UNITED STATES PATENT AND TRADEMARK OFFICE

10/648,466

Office Action Summary	Application No.		Applicant(s)	
	10/648,466		JANESKY ET AL.	
	Examiner		Art Unit	
	Thinh T Nguyen		2818

DETAILED OFFICE ACTION

Fig. 3A

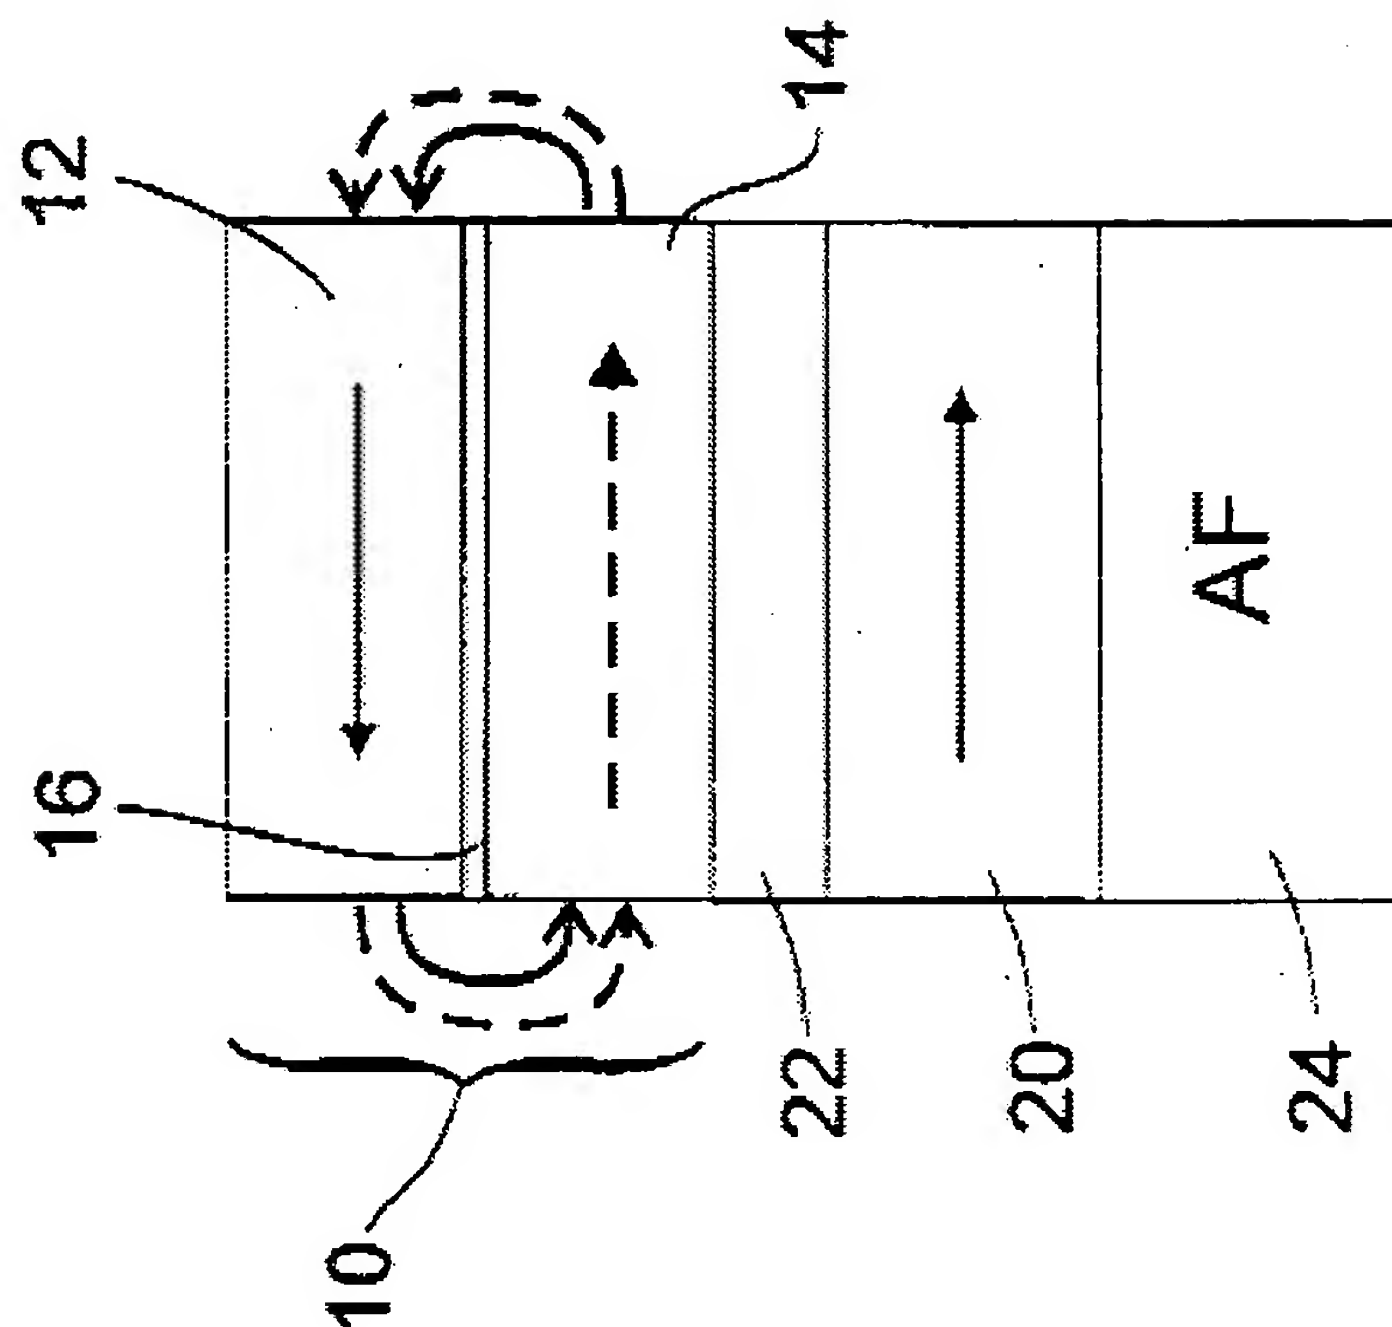
Parkin et al. (fig 3A, the title, the abstract) disclose a multi-state, multi-layer magnetic memory device comprising: a nonmagnetic spacer region (fig 3A layer 22) with a surface and an opposed surface; a free magnetic region (fig 3A layer 10, column 6 line 24) positioned adjacent to the surface of nonmagnetic spacer region, the free magnetic region including and a plurality of magnetic layers; wherein a free magnetic layer positioned adjacent to the surface of the nonmagnetic spacer region in the plurality of magnetic layers has improved material quality.

Parkins et al (fig 3A, layer 16, the abstract) disclose a magnetic memory device wherein the free magnetic region includes at least one layer of an anti-ferromagnetic coupling spacer material.

Parkins et al. (the abstract, fig 3A, column 7 line 50) disclose a magnetic memory device wherein the anti-ferromagnetic coupling spacer material includes at least one of copper (Cu), chromium (Cr), or ruthenium (Ru).

Parkins (the abstract, fig 3A, column 7 line 49) disclose a magnetic memory device wherein the free magnetic region includes at least one of nickel (Ni), iron (Fe), cobalt (Co).

Parkins (the abstract, fig 3A free region 10) disclose a magnetic memory device wherein the free magnetic region includes a synthetic anti-ferromagnetic material region including N ferromagnetic layers which are anti-ferromagnetically coupled where N is a whole number greater than or equal to two.

Parkins (the abstract, fig 3A free region 10) disclose a magnetic memory device wherein each N ferromagnetic layer is anti-ferromagnetically coupled by sandwiching a layer of an anti-ferromagnetic coupling material (fig 3A layer 16) between each adjacent ferromagnetic layer in the N ferromagnetic layers.

Parkins (the abstract, fig 3A) disclose a magnetic memory device wherein a fixed magnetic region (fig 3A, layer 20) is positioned on the opposed surface of the nonmagnetic spacer region.

Parkin et al. (fig 3A, the title, the abstract) disclose a magnetic memory device wherein the magnetic layer positioned adjacent to the surface of the nonmagnetic spacer region in the plurality of magnetic layers is deposited.

Parkin et al. (fig 3A, the title, the abstract, column 4 line 50) disclose a magnetic memory device wherein the non magnetic spacer region is aluminum oxide

Parkin et al. (fig 3A, the title, the abstract) disclose a magnetic memory device wherein the one ferromagnetic layer (fig 3A layer 14) of the synthetic anti-ferromagnetic material region that is positioned adjacent to the surface of the nonmagnetic spacer is at least as thick as any of the other N ferromagnetic layers (fig 3A layer 12) which comprise the synthetic anti-ferromagnetic material region.

FIG. 1

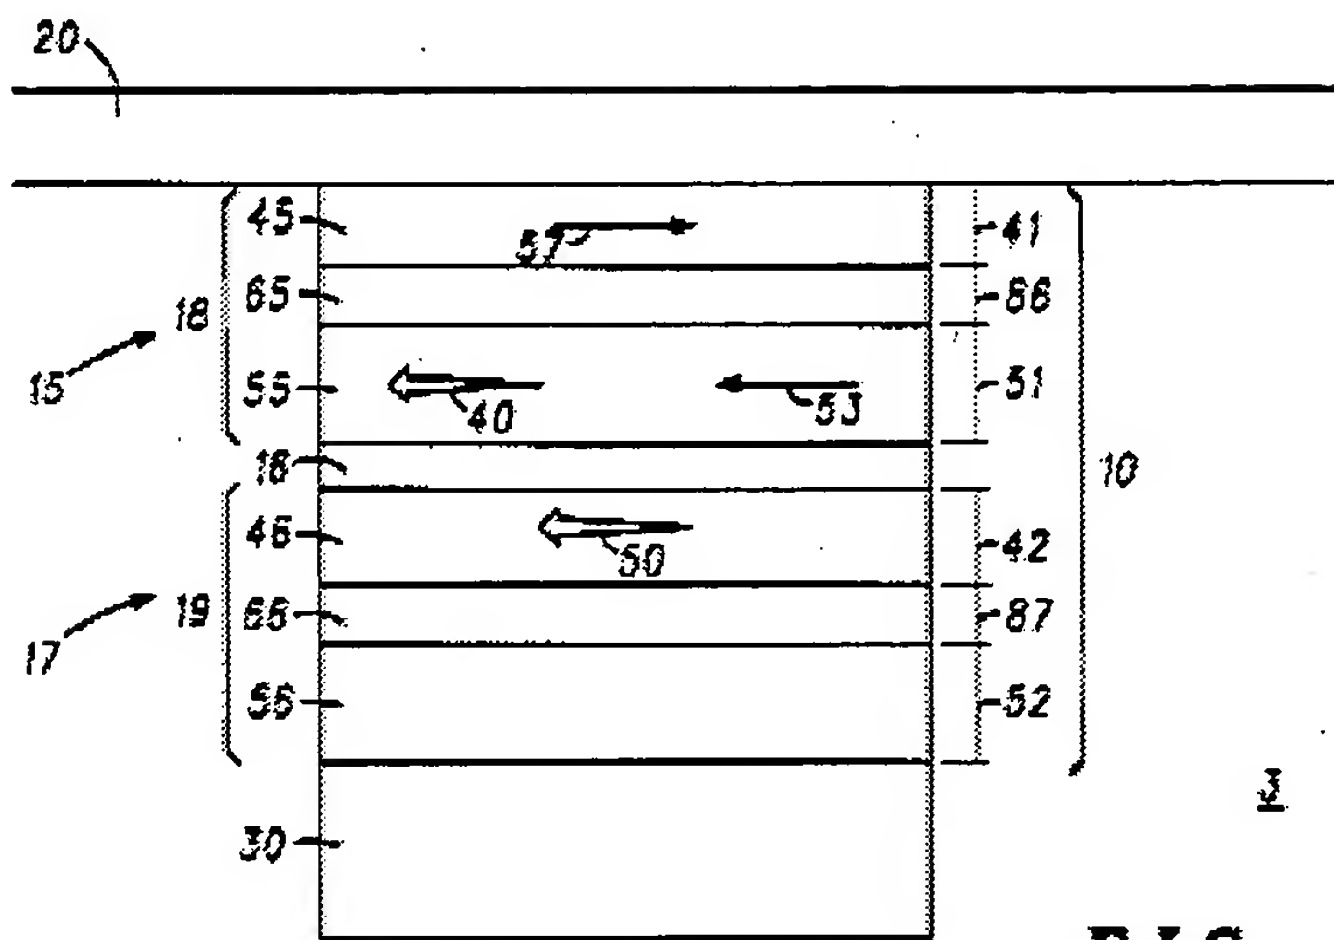
Similarly, Savtchenko et al. (fig 1, free layer 15, column 2 lines 31-33, the abstract, spacer 16) disclose the same invention.

Similarly Savtchenko et al. (fig 1, column 2 line 38-47) disclose the same invention.

Similarly, Savtchenko et al. (fig 1, free layer 15, column 5 lines 54-56, the abstract) disclose the same invention.

Similarly, Savtchenko et al. (fig 1, free layer 15, the abstract) disclose the same invention.

Similarly, Savtchenko et al. (fig 1, free layer 15, the abstract) disclose the same invention.

Similarly, Savtchenko et al. (fig 1, layer 46, the abstract) disclose the same invention.
